**COMMISSION OF ARCHITECTURAL REVIEW**  
**STAFF REPORT**  
**September 27, 2016 Meeting**

**10. CAR No. 16-135 (J. Bolton)**

**2230 Venable Street  
Union Hill Old and Historic District**

**Construct two new multifamily structures  
and rehabilitate an existing structure to  
include new windows.**

Sanborn Map 1924

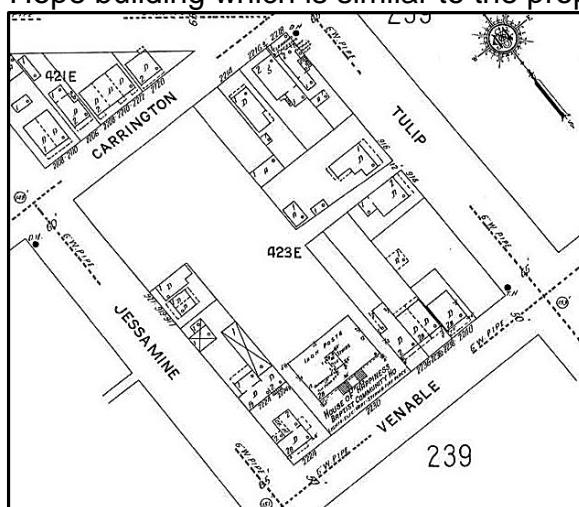
Per the 1924 Sanborn map, the structures that addressed Jessamine were minimally setback from the street which is consistent with the proposed setback. The Sanborn map also indicates that the structure to the east of the Citadel of Hope building sat proud of the Citadel of Hope building which is similar to the proposed setback.
